RE: BAIADA INTEGRATED POULTRY PROCESSING FACILITY (SSD 9394) – RESPONSE TO SUBMISSIONS

RESPONSE TO SUBMISSIONS

Figure 5.2 – Predicted ground level odour concentration – Sensitivity Analysis

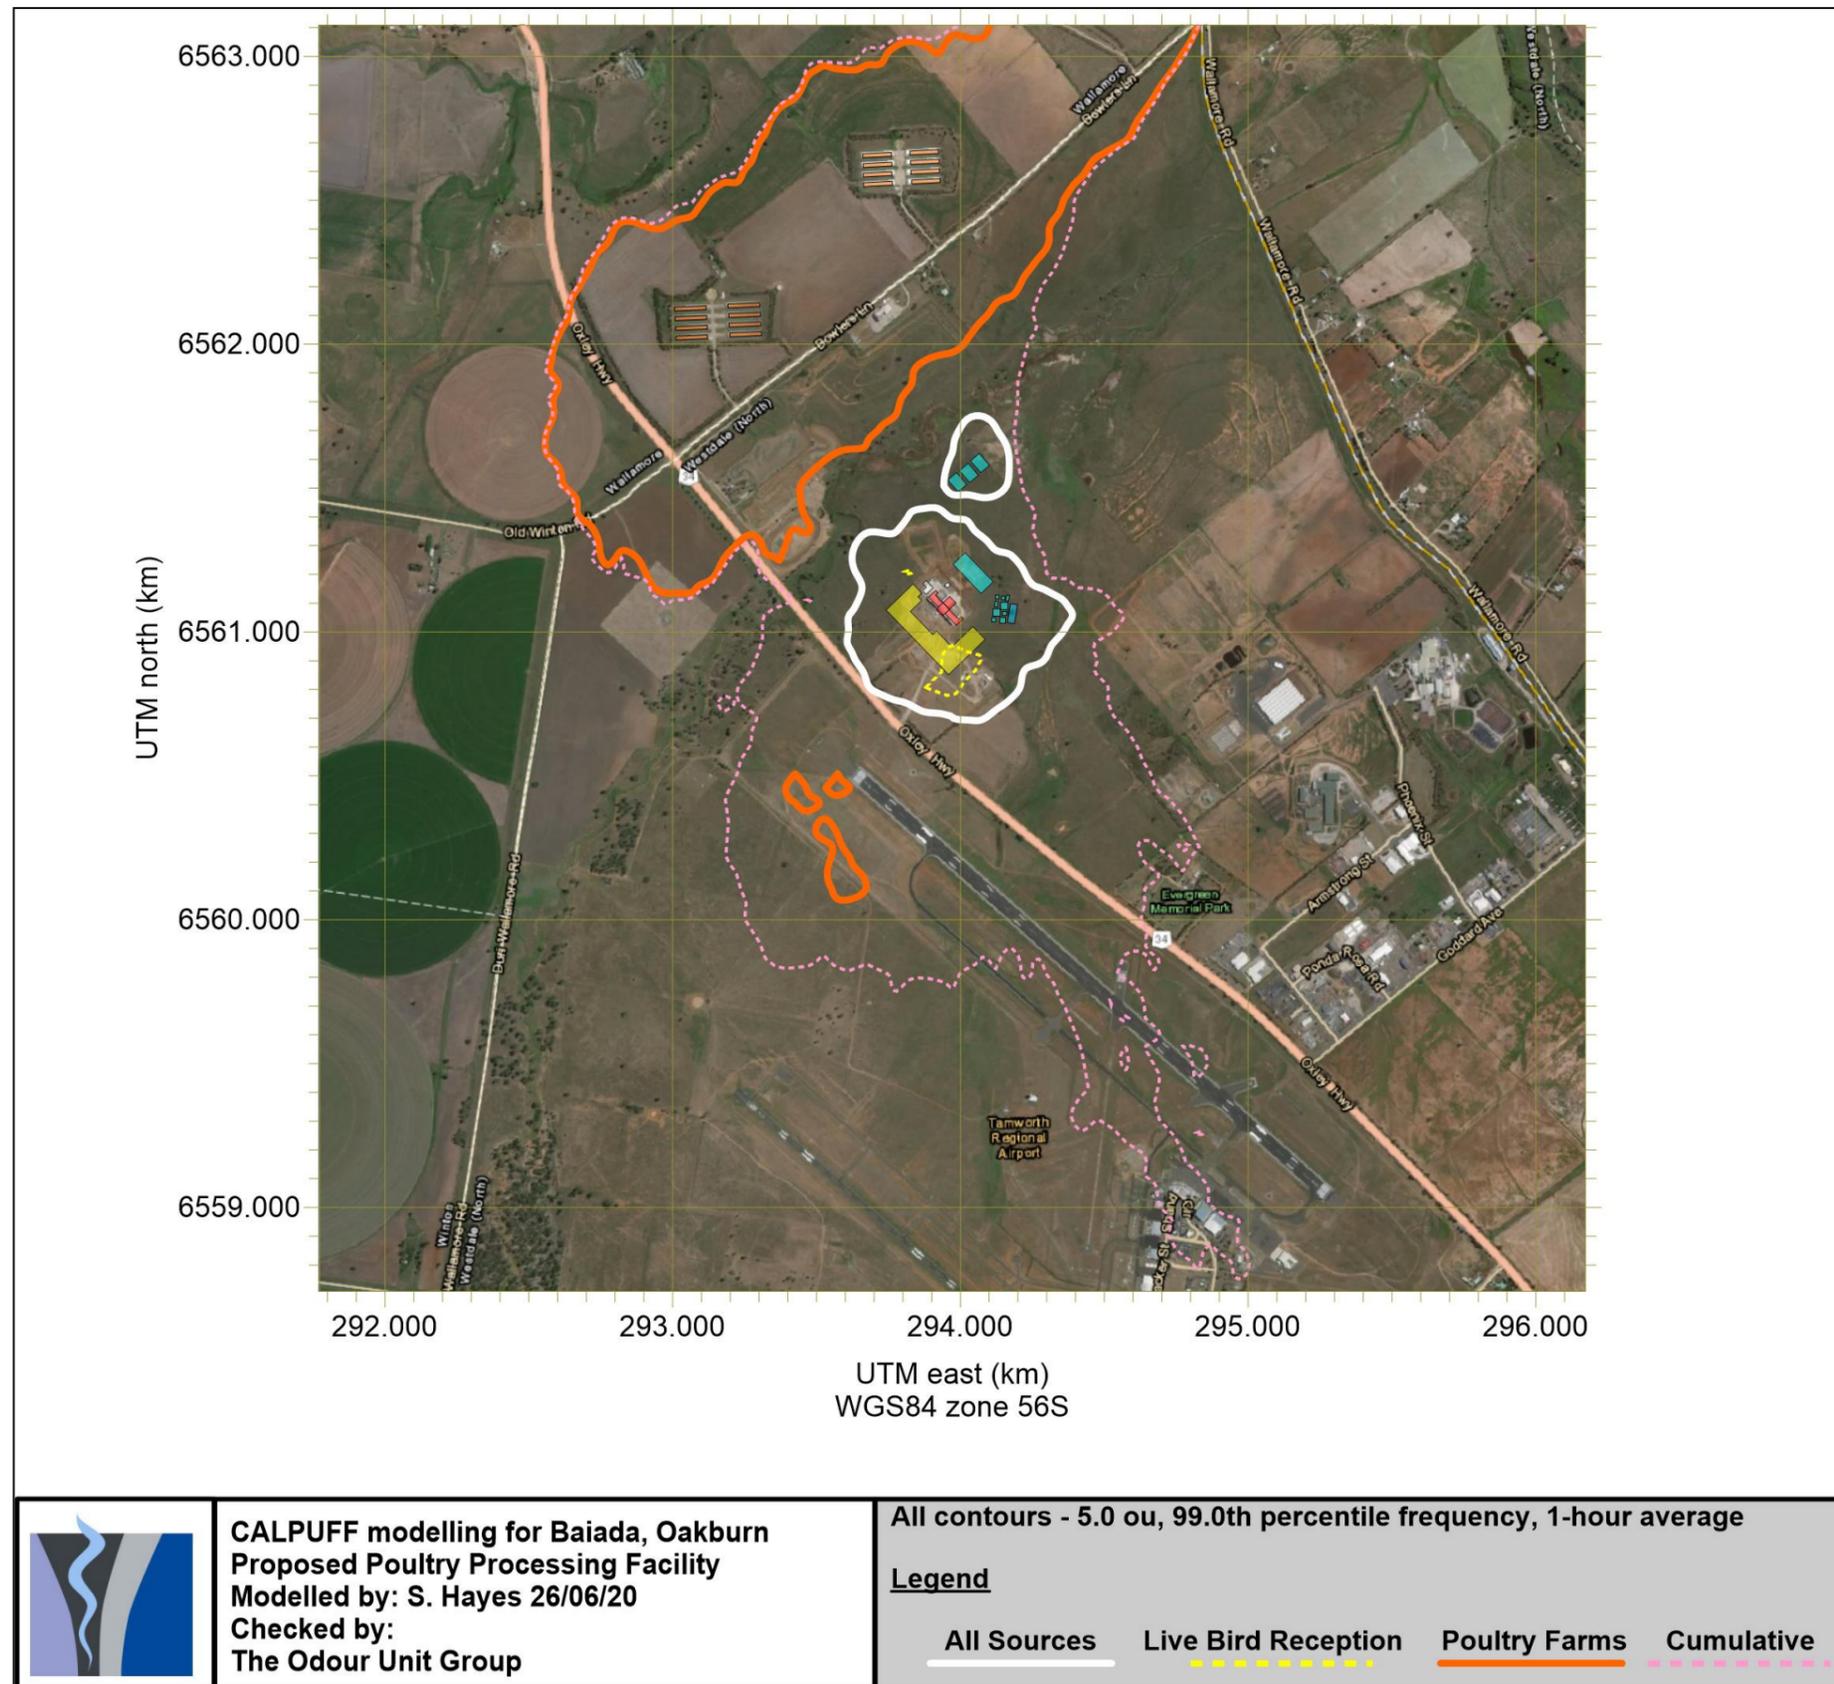
<p><u>Cumulative odour effects from poultry farm not included in odour assessment</u></p> <p><i>The AQR has not considered or included the odour from the poultry farms located to the north-west of the proposed development (Figure 1.1). The cumulative effect of the odour resulting from the existing poultry farms and the proposed poultry processing facility may result in a cumulative odour impact over the IAC of 5 OU at a sensitive receptor located between the two sites.</i></p> <p><i>The AQR needs to be revised to include a cumulative odour assessment of the proposal and all poultry facilities in the vicinity of sensitive receptors.</i></p>	<p>The cumulative odour effects from the proposed Poultry Processing Facility have been considered, along with the cumulative odour effects from the three poultry farms along Bowlers Lane in the form of a sensitivity test.</p> <p>The prediction of cumulative effects shown in Figure 5.2 of the Odour Impact Assessment is almost certainly overstated as it considers all Oakburn sources including treated odours (e.g. biofilter) and odours of different characters (e.g. rendering, wastewater, etc) that do not combine in the atmosphere and tend to be observed as individually identifiable odour characters in the field.</p> <p>A more realistic analysis more in line with TOU's expectation of odour impact risk would consider the cumulative effect of the poultry farm (orange) contour with the Live Bird Reception (dashed yellow) contour that has a similar live bird odour character.</p>

The results in **Figure 3.2** reflects a sensitivity analysis for the 5.0 ou contour (99%, P/M60), where the cumulative odour effects are considered from Bowlers Lane poultry farms, namely:

- A more realistic analysis consistent with TOU’s expectations of odour impact risk would consider the cumulative effect of the poultry farm (orange) contour with the LBR (dashed yellow) contour that has a similar live bird odour character.
